System Impact Assessment Report (Addendum)

McLean's Mountain Wind Farm

CAA ID 2010-386

March 15, 2011

Figure 1: Proposed Connection Arrangement

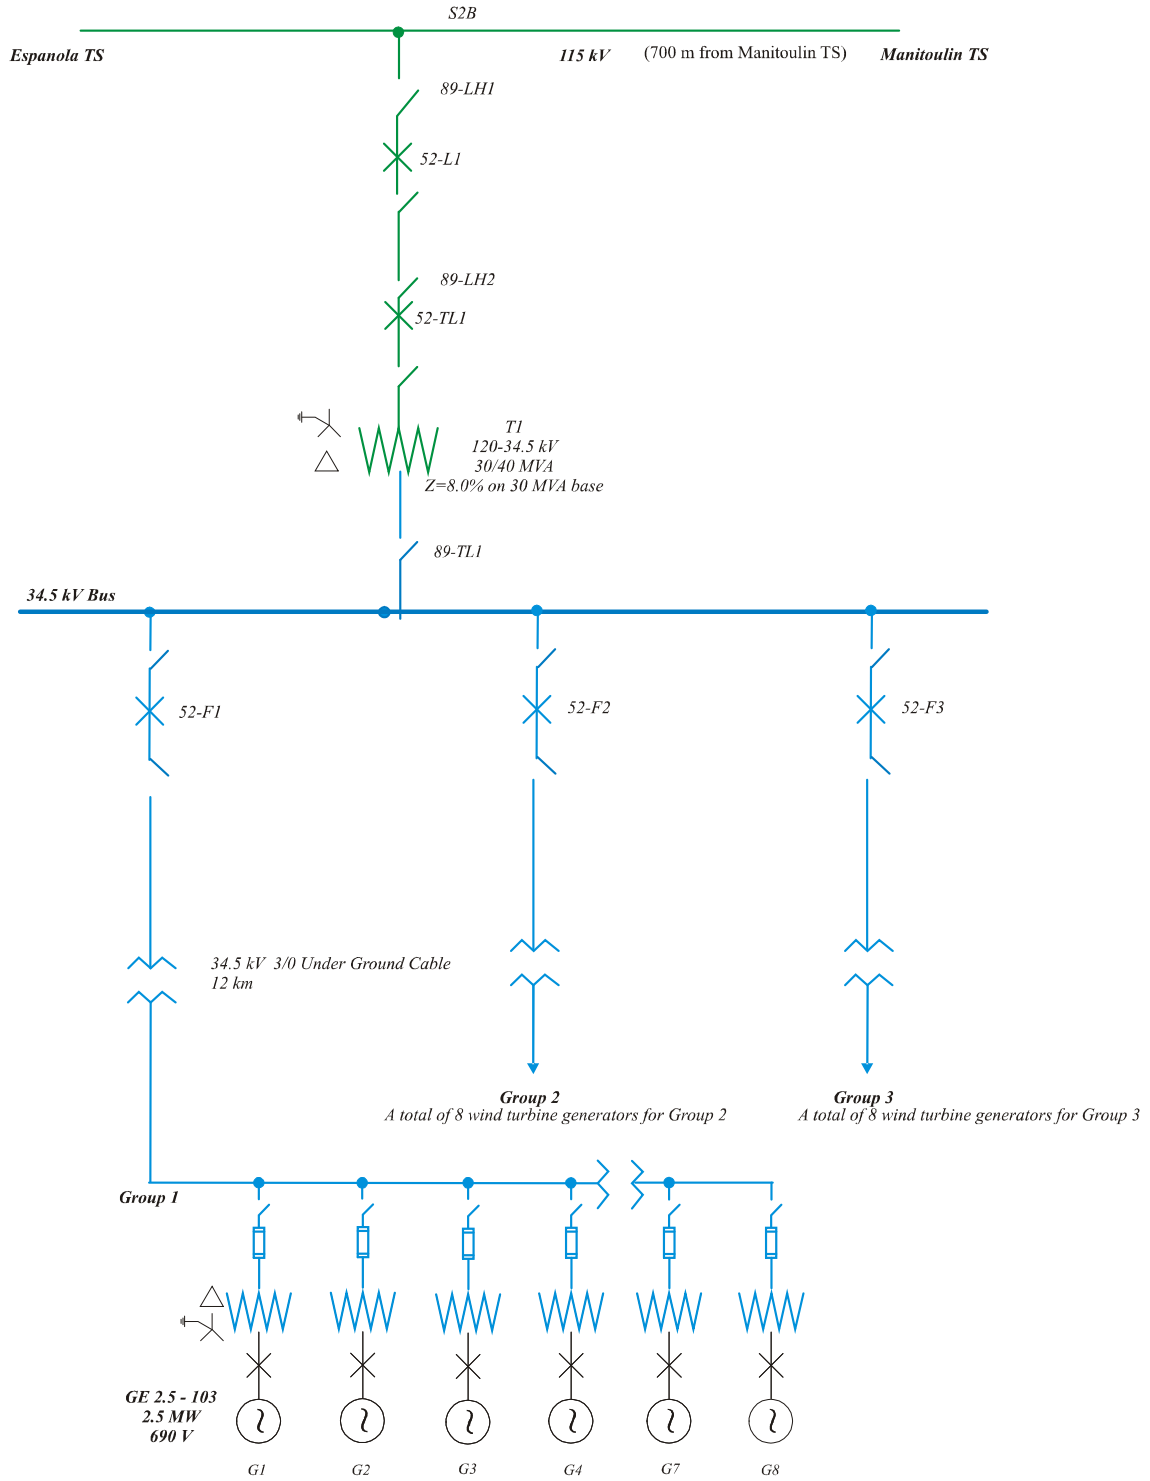
With the exception of the number of generators connected to each feeder, the connection arrangement remains the same as what was evaluated in the original SIA assessment. The development will consist of a total of 24 GE-103 12.5 60 Hz wind turbine generators with a rated power output of 2.5 MW each. Each generator is connected to a power converter system and is connected to one of three collector circuits C1, C2 and C3 via a 0.69/34.5 kV (0.06 pu reactance on 2.8 MVA) transformer. The facility will be tapped to the IESO controlled grid via the 115 kV circuit S2B.

Figure 2: GE 2.5-103 LVRT II Model Settings

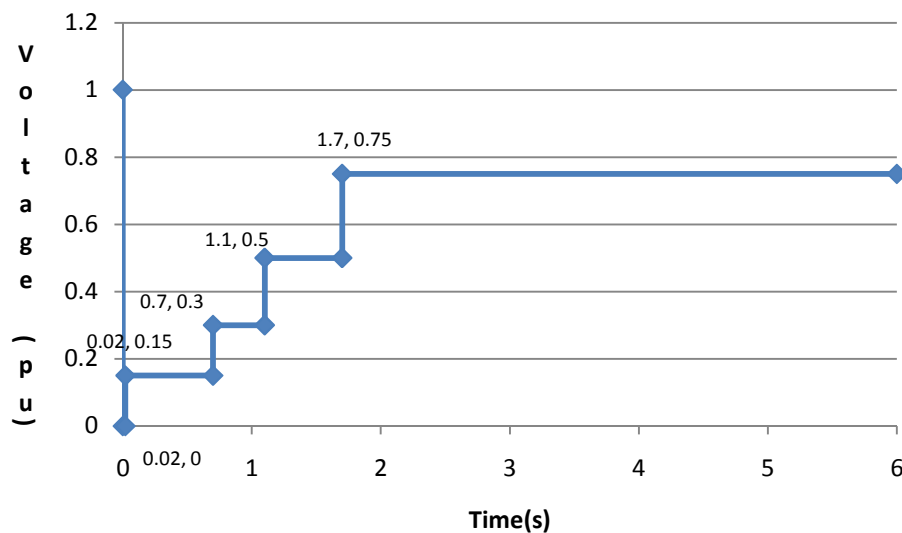
During low voltage ride through, as long as the generator terminal voltage is above the curve shown in **Figure 2**, the turbine will remain connected.

It is expected that no change to the above LVRT settings are required for the implementation of McLean’s Mountain.

Figure 3 – McLean’s Wind Farm Terminal Voltage Vs LVRT Protection Curve (SC1 to SC7)

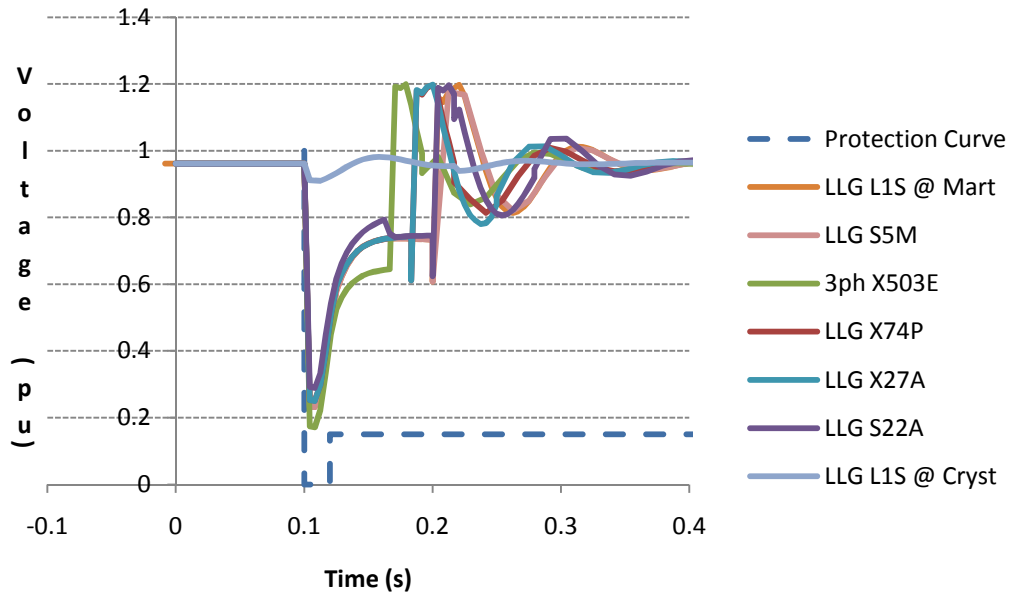
In order to examine the need for low voltage ride through (LVRT) capability, the terminal voltage of the wind generator was monitored for all eleven contingencies. The variation of the terminal voltage of the new generation facility is plotted in **Figure 3** below for the SC1 to SC7 contingencies and **Figure 4** below for the SC7 to SC11 against the LVRT protection curve. Note, as the fault was applied at $t=0.1s$, each timeout setting was shifted by 0.1s. It can be seen that the voltage response is well above the LVRT protection curve. Therefore, fault ride through capability of the proposed wind turbines is adequate.
